## > Customer Product Information (CPI)

<b>Product group:</b>	<b>SEMIPACK</b>	<b>Rev.: 1</b>
<b>No.:</b>	<b>PN20-096</b>	<b>02 Nov 2020</b>
<b>Minor change of DBC layout for SEMIPACK 2 modules (time schedule updated)</b>

**Current DBC layout (as example SKKT 162)**

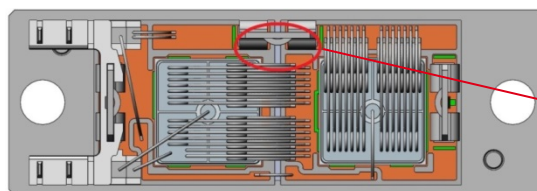
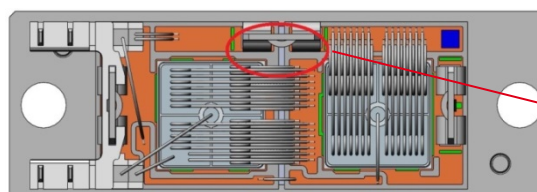
**Description of change:** Changes in the marked area to achieve constant larger distance between the terminal feet and the adjacent copper area. The change does not affect the current path and has no impact on electrical and mechanical properties of the modules.
